MAF/L501 series L Type Bracket

Change Notification

MAF501, MAL501, MAF501D/M

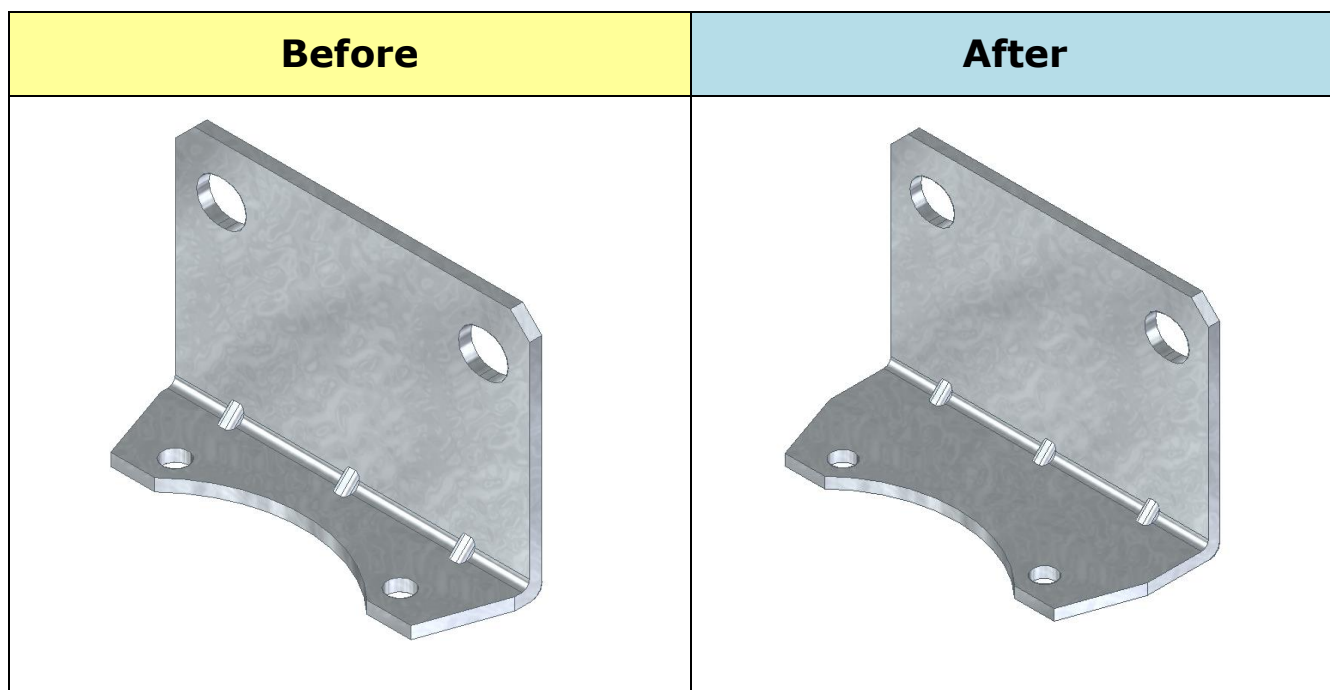
In response to market demand, L type bracket distance from the body will be modified to the same distance as the MAFR / R501 bracket.
